PRODUCT CHANGE NOTIFICATION (PCN)

A-MCUP-80005 MODULAR CABLE

CHANGE NOTIFICATION: PCN 20220425_A-MCUP-80005

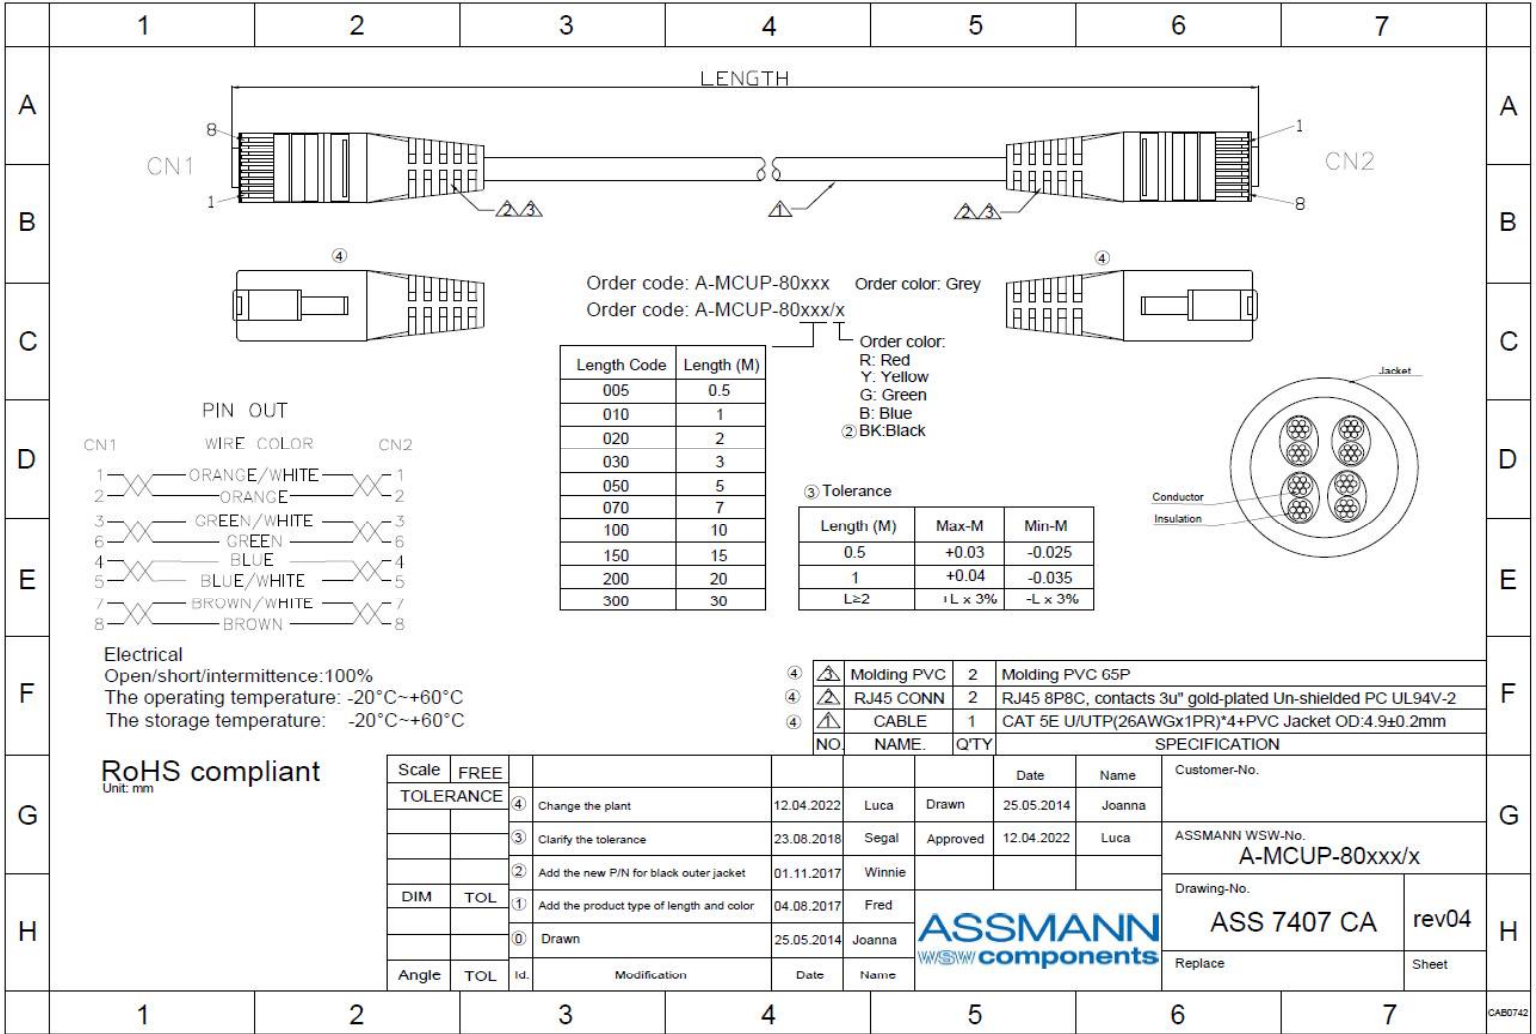
NO.	NAME.	QTY	SPECIFICATION																																
③	Molding PVC	2	Molding PVC 45P																																
②	RJ45 CONN	2	RJ45 8P8C, Two Fork gold plated contacts 3u" gold																																
①	CABLE	1	UTP(26AWG*x1PR)*4+PVC OD:4.9±0.2mm																																
NO.	NAME.	QTY	SPECIFICATION																																
④	⚠ Molding PVC	2	Molding PVC 65P																																
④	⚠ RJ45 CONN	2	RJ45 8P8C, contacts 3u" gold-plated Un-shielded PC UL94V-2																																
④	⚠ CABLE	1	CAT 5E U/UTP(26AWGx1PR)*4+PVC Jacket OD:4.9±0.2mm																																
<p>FOR DETAIL, PLEASE TAKE ATTACHED NEW DRAWING: FOR REFERENCE</p>
